**Conditionally
APPROVED**

1000 GALLON 2 - COMPARTMENT SEPTIC TANK	LEDGEVIEW PRECAST CONCRETE INC.
	N6672 COUNTY RD. UU FOND DU LAC, WI 54937
PRODUCT FILE # TBD	920-921-2530
MODEL# 1000 GAL. 2 - C

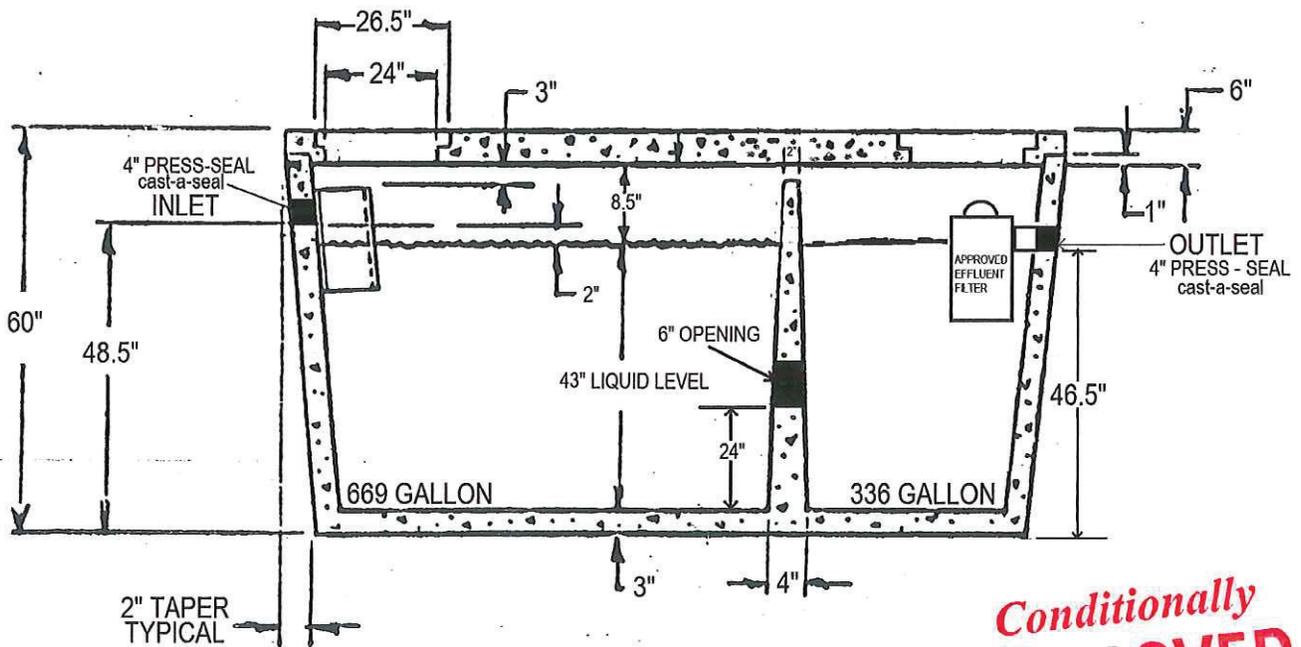
SEE CORRESPONDENCE
